RE: Pison Teklogix Inc.

FCC ID: GM375273RADA

After a review of the submitted information, I have a few comments on the above referenced Application.

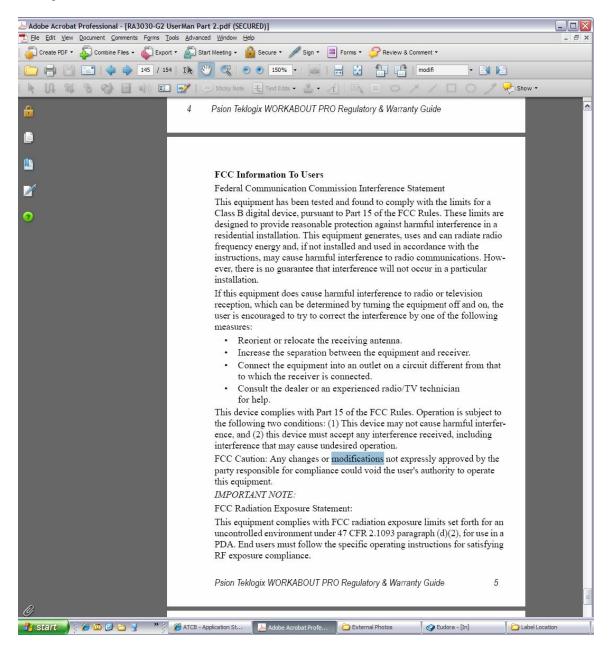
- 1) I currently do not have any information regarding the tune-up procedure for this device.
- 2) There is still confusion on the labeling. Please explain the labeling of the host. If more than one label gets applied to the external portion of the device, please clarify the location photograph. The device should show the "Contains FCC ID:" for both co-located transmitters. Currently it appears that only the BT label would be externally viewable.
- Regarding labeling of the host. The label for the host appears to be being placed under a battery. Please note the following which should be supported in the application. Currently items in Blue have not been adequately supported in the application:

Page 3

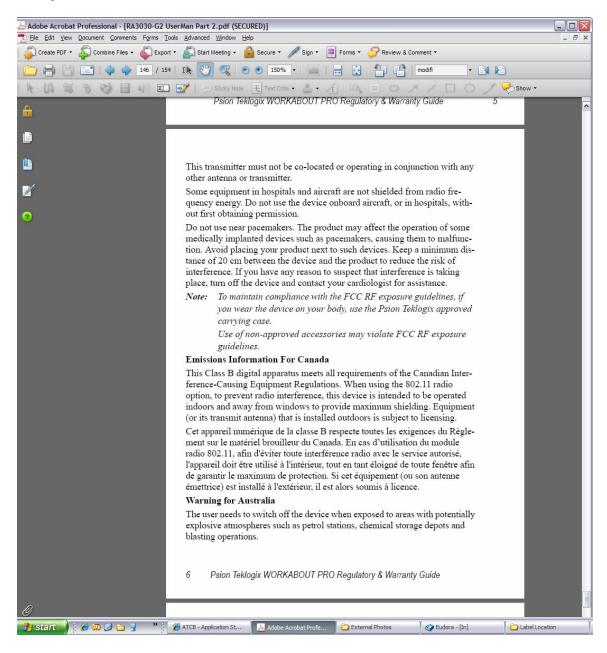
- 4) The most recent updated manual lost a lot of FCC information, specifically 15.105, 15.21, 2 part statement of 15.19, RF exposure information, no-colocation information, and IC information seen originally as follows:
